# ENGINEERING CHANGE ORDER

REQUEST DATE	2/1/2024	REQUESTED BY	H. AMEZQUITA	REQUESTED RELEASE DATE	2/15/2024	ECO #	<b>ECO-00121</b>
AFFECTED PRODUCT LINES	ALL CHAIN OPERATED PRODUCTS – USA ORDERS ONLY						
REASON FOR CHANGE	UPDATE WARNING MARKINGS TO MEET ANSI2022 STANDARDS (5.2.1 AND 5.1.1)						
DESCRIPTION OF CHANGE	UPDATE WARNING LABEL AND WARNING TAG FORMAT AND ARTWORK TO MEET NEW ANSI2022 REQUIREMENTS.						
COST IMPACT	MEET0129 CURRENT COST: \$ 0.0540 USD, NEW COST: \$0.0898 USD, MEET0128 CURRENT COST: \$ 0.0440 USD, NEW COST: \$0.0612 USD, MEET0127 CURRENT COST: \$ 0.0440 USD						
DOCUMENT / PART NUMBER	OLD REV	NEW REV	DOCUMENT/ PART DESCRIPTION	CHANGE DESCRIPTION	FORM, FIT, OR FUNCTION AFFECTED <small>Yes, or No</small>	PART DISPOSITION <small>(USE AS IS) (REWORK) (SCRAP) (OBSOLETE) (RETURN TO VENDOR) (OTHER)</small>	
MEET0129	-	-	WARNING RAIL LABEL 5.1.1	<b>CHANGE DESCRIPTION TO:</b> LABEL, WARNING ANSI2022 5.1.1, 154 X 25.4 MM  CHANGE FORMAT AND ARTWORK (SEE PAGE 3 AND 4)	NO	SCRAP INVENTORY AFTER ANSI2022 CONVERSION DATE

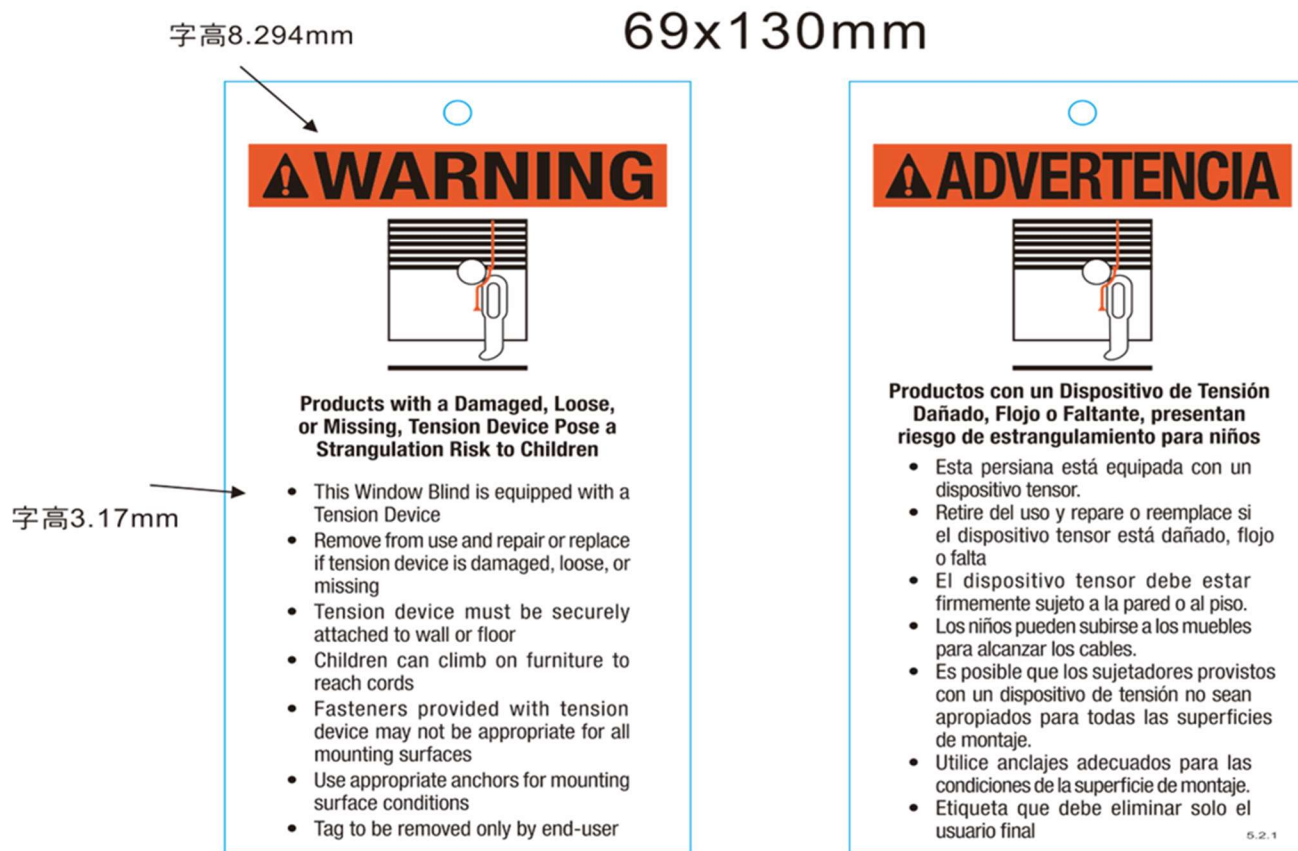
MEET0128	-	-	WARNING HANG TAG 5.2.2	<b>CHANGE DESCRIPTION TO:</b> TAG, WARNING ANSI2022 5.2.1, 69 X 130 MM  CHANGE FORMAT AND ARTWORK (SEE PAGE 3, 5 AND 6)	NO	SCRAP INVENTORY AFTER ANSI2022 CONVERSION DATE	
MEET0127	-	-	WARNING HANG TAG 5.2.1	<b>OBSOLETE PART NUMBER</b>	NO	SCRAP INVENTORY AFTER ANSI2022 CONVERSION DATE	
ADDITIONAL INFORMATION	STARTING PO# 1939175						
<b>AFFECTED DOCUMENTS / PROCESSES (CHECK ALL THAT APPLY)</b>							
BOM / CONFIG	<input checked="" type="checkbox"/>	PRODUCT / PART SPEC	<input checked="" type="checkbox"/>	QC CHECKLIST	<input checked="" type="checkbox"/>	PART DRAWING	<input type="checkbox"/>
				ASSEMBLY DRAWING	<input type="checkbox"/>	INSTR SHEET	<input type="checkbox"/>
				PROCESS VISUAL AIDS	<input checked="" type="checkbox"/>	WORK INSTRUCTIONS	<input type="checkbox"/>
<b>ECO APPROVALS ROUTING</b>							
APPROVER	APPROVAL REQUIRED	APPROVER NAME	APPROVAL STATUS	APPROVED ON	NOTES
